LEE'S SUMMIT
MISSOURI
Development Services Department

Development Services Staff Report

File Number	PL2024-129 – PRELIMINARY DEVELOPMENT PLAN – Dunkin Lee's Summit
Applicant	Bluemont Group, LLC
Location	1399 NE Douglas St
Planning Commission Date Heard by	August 22, 2024 Planning Commission and City Council
Analyst	Ian Trefren, Planner

Figure 1 - Proposed building site plan

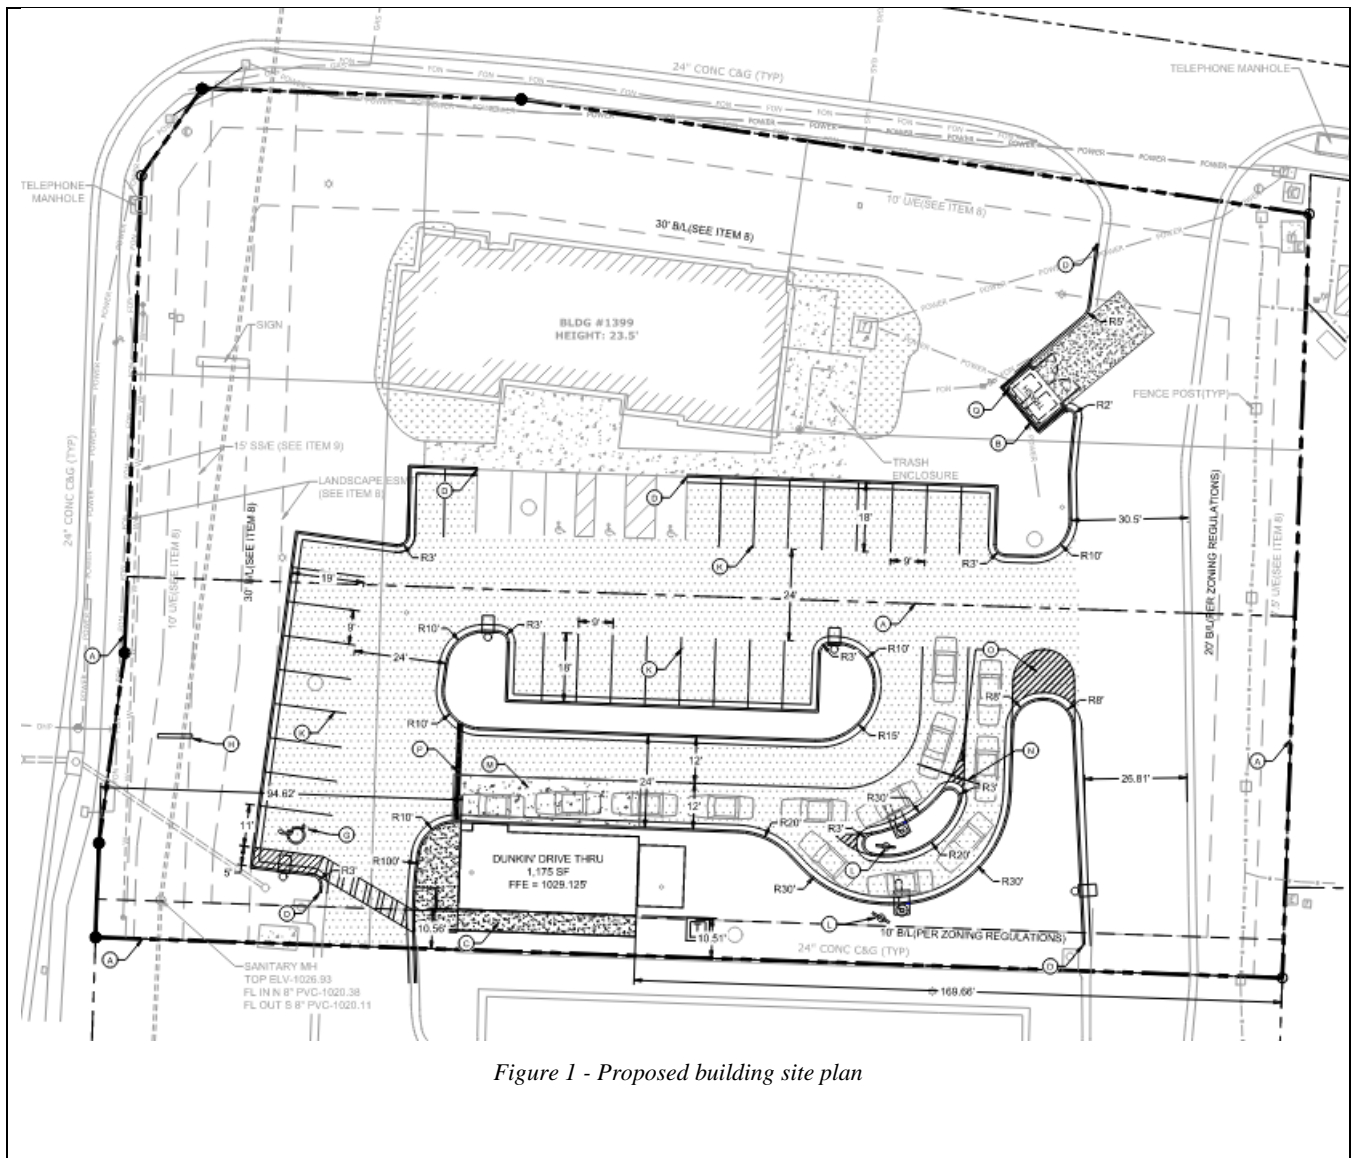
The proposed development calls for the removal of 35 of the existing 69 parking spaces. The remaining 34 spaces will serve the existing dental office building and the new drive-through doughnut/coffee shop. The minimum total number of parking spaces to serve both uses is 29 parking spaces, so minimum parking standards will continue to be met on the site.

^A – At the time the project site is re-platted from 1 lot to 2 lots, 16 parking spaces will be located within the doughnut/coffee shop lot boundaries and 18 parking spaces will be located within the dental office building lot boundaries.

Internal to the site, the proposed drive-through doughnut/coffee shop meets adequate vehicle stacking requirements. The proposed dual-lane drive-through facility provides stacking for a total of 6 vehicles from the pick-up window and a total of 7 vehicles from the order box. The minimum stacking requirements are 4 vehicles from the pick-up window and 5 vehicles from the order box.
